# **Contractor Package Version 20231011 Addendum 1: Key Changes in 2023 Autumn Release of Standards and Contractor Package**

Prepared by:  
Ministry of Water, Land and Resource Stewardship  
Ecosystem Information Section  
Terrestrial Ecosystem Information Unit

**November 2023**

#### BGC\_LBL

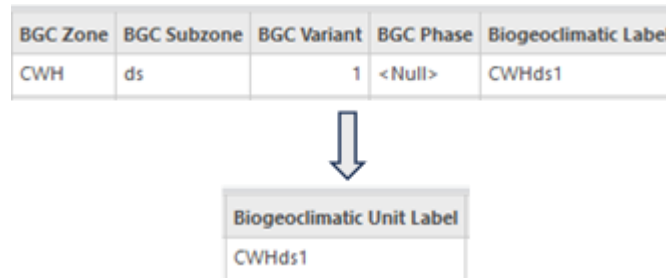
The biogeoclimatic (BGC) unit fields represented by BGC Zone (*BGC\_ZONE*), BGC Subzone (*BGC\_SUBZON*), BGC Variant (*BGC\_VRT*), BGC Phase (*BGC\_PHASE*) and BGC Validation (*BGC\_VLD*) have been replaced by a single Biogeoclimatic Unit Label (*BGC\_LBL*) field.

Example usage of new **BGC\_LBL** field compared to the previous version to record “Coastal Western Hemlock/Dry Submaritime/Southern”.

## DIST\_LBL#

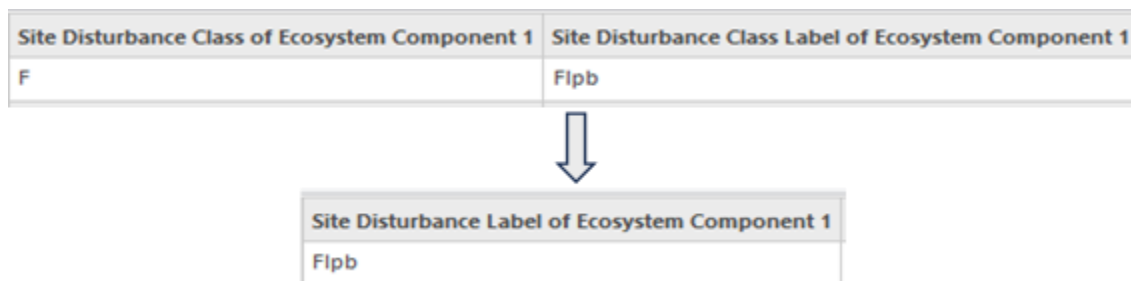
The site disturbance fields represented by Disturbance Class (**DISTCLS\_#**), Disturbance Subclass (**DISTSCLS\_#**), Disturbance Subsubclass (**DISSSCLS\_#**) and Disturbance Class Validation (**DISTCLS\_VLD#**) have been replaced by a single Site Disturbance Label (**DIST\_LBL#**) field. The Site Disturbance Label contains a string of character codes representing the site disturbance label, which is a concatenation of Site Disturbance class, subclass and subsubclass codes.

Example usage of new **DIST\_LBL1** field compared to the previous version to record “Fires: burning of logging slash: piled and burned”.
